Access Compliance Report

Public Rights-of-Way

(Curb Ramps)

Intersection ID: 48946	Main Street: DAVID_JENNINGS_AV	Cross Street: MITCHELL_GRANT_WY	Location: W
ADA ID: 056525F7EE44	Ramp Type: Perp	Initial Pass/Fail: Fail	Overall Compliance: No
Severity Score: 21.25			
Codes/Mitigation Info/Possible Solution		Field Measurements/Component Compliance

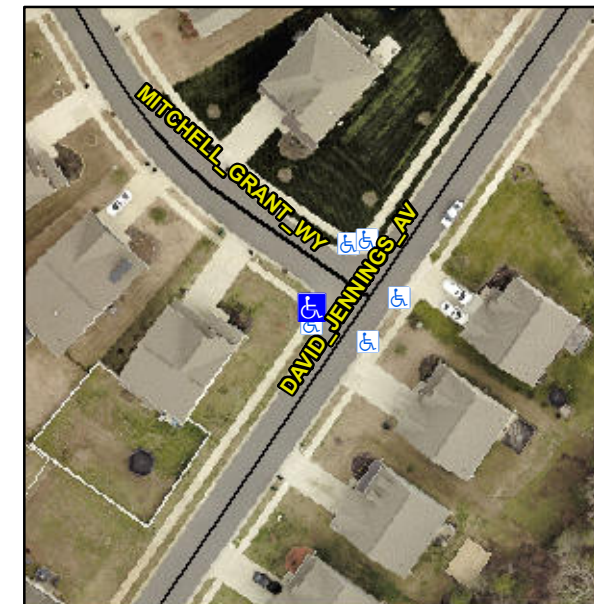
Not Found, R304.5.1, R304.2.2

Compliance	Description	Data	Compliance	Description	Data
N/A	Ramp Length (in)	48.0	No	Ramp Slope (%)	8.9
No	Ramp Width (in)	47.5	Yes	Ramp XSlope (%)	0.7
N/A	Flare Type LT	N/A	N/A	Flare Type RT	N/A
N/A	Flare Slope LT (%)	N/A	N/A	Flare Slope RT (%)	N/A
N/A	Flare Traversable LT?	N/A	N/A	Flare Traversable RT?	N/A
N/A	Landing Length (in)	N/A	N/A	DWS Provided?	N/A
N/A	Landing Width (in)	N/A	N/A	DWS Contrast?	N/A
N/A	Landing Slope (%)	N/A	N/A	DWS Length (in)	N/A
N/A	Landing X Slope (%)	N/A	N/A	DWS Full Width?	N/A
N/A	Landing Curb? (Y/N)	N/A	N/A	DWS Offset (in)	N/A
N/A	Shared Landing?	N/A			
N/A	Gutter Ponding?	N/A	N/A	Gutter Slope (%)	N/A
N/A	Gutter Lip Ht (in)	N/A	N/A	Gutter X Slope (%)	N/A
N/A	Painted X Walk1?	No	N/A	Painted X Walk2?	N/A
	X Walk 1 Direction	To NE		X Walk 2 Direction	N/A
N/A	X Walk 1 Width (in)	N/A	N/A	X Walk 2 Width (in)	N/A
	X Walk 1 Slope (%)	0.7		X Walk 2 Slope (%)	N/A
	X Walk 1 X Slope (%)	0.1		X Walk 2 X Slope (%)	N/A

Remove & Replace Entire Ramp.
